Service Bulletin

Bulletin No.: PI0756B

Subject: Retrofit Procedure for New Corded Folding Top Cover Installation to Original Design Frame

Models: 2011-2012 Chevrolet Camaro Convertible

Early Design #2 Bow Bracket

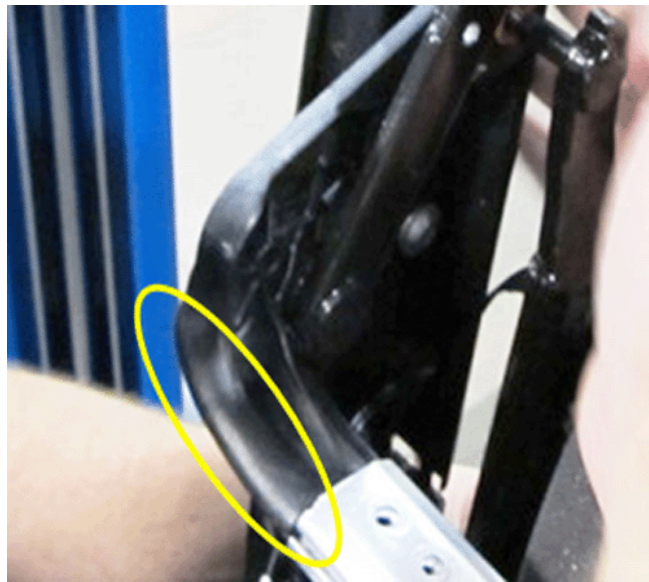
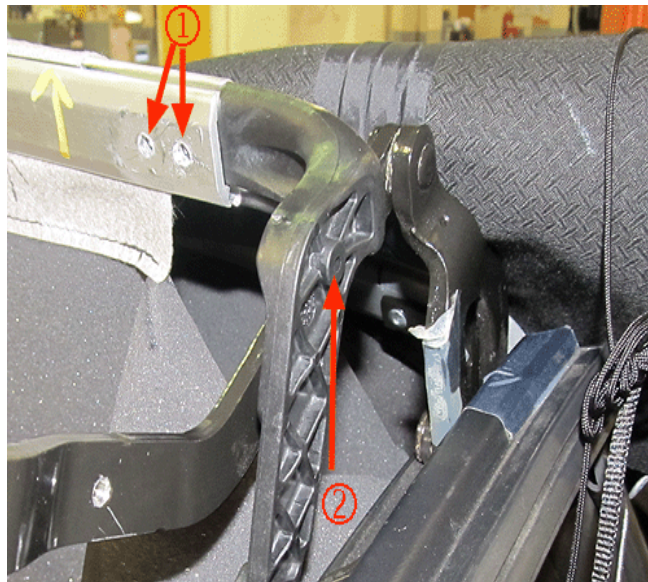
Important: The #2 bow end brackets are made of plastic and will likely break/snap during removal. Two new brackets are included with the top cover replacement kit. Regardless of breakage, all early design #2 bow brackets should be replaced.

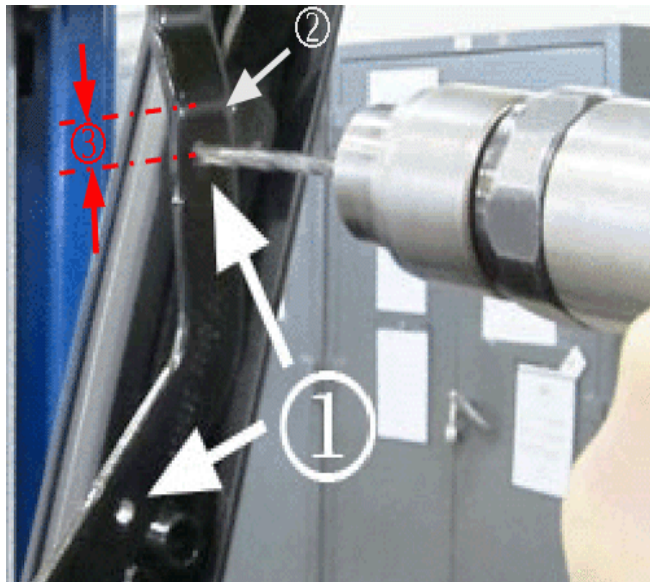
Important: The two holes added to the #2 bow should be centered on the bow and ARE NOT through holes. DO NOT drill through to the topside of the #2 bow.

11. While the #2 bow is removed, drill two 5 mm (0.197 in) holes (1) in the underside of the #2 bow. Position the holes 102 mm (4.0 in) from each end of the bow.

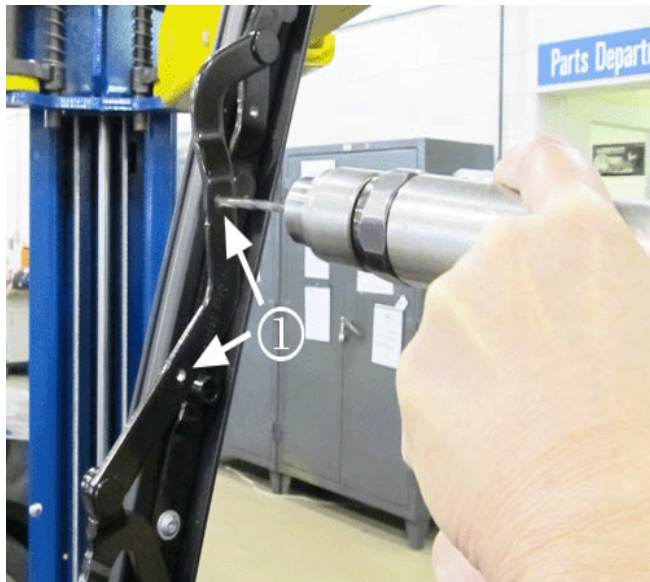
Note: Older convertible tops may be missing the upper 3.2 mm diameter hole shown in the control link above. If the hole is missing, add by drilling a new 5 mm (0.197 in) hole positioned 10 mm (0.40 in) (3) from the bend radius (2). Repeat the same operation on the opposite side of the top.

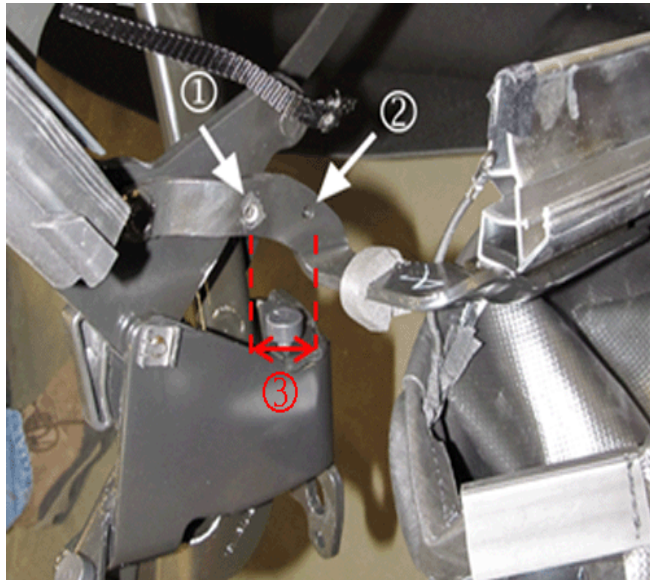
13. Re-drill the two existing 3.2 mm (0.125 in) holes (1) in the left control link to open the diameter up to 5 mm (0.197 in). Repeat the same operation on the opposite side.

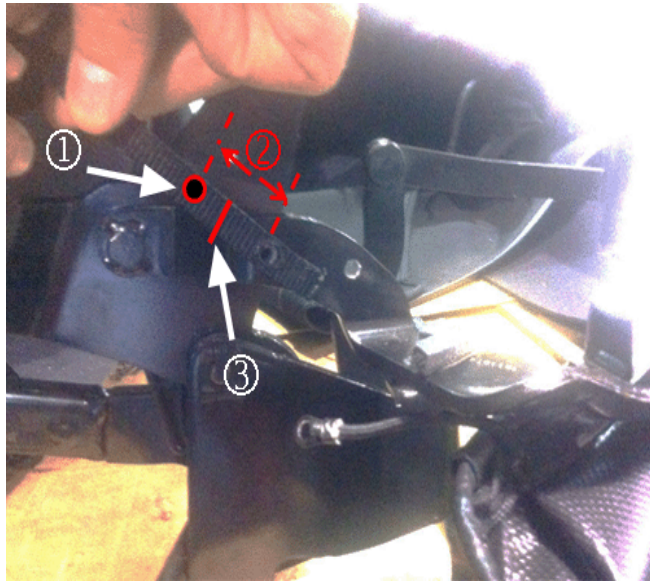
15. The graphic above shows the left #5 bow bracket with the strap and cords removed, and also the orientation of the new hole (1) and existing hole (2) for illustration purposes only.
 - 15.1. Drill a 5 mm (0.197 in) hole into the left and right #5 bow brackets, positioned 30 mm (1.12 in) (3) from the hole where the rear headliner strap and water management bag cord are attached.
 - 15.2. Drill out the original rivet retaining the strap and cord for repositioning those to the new hole.
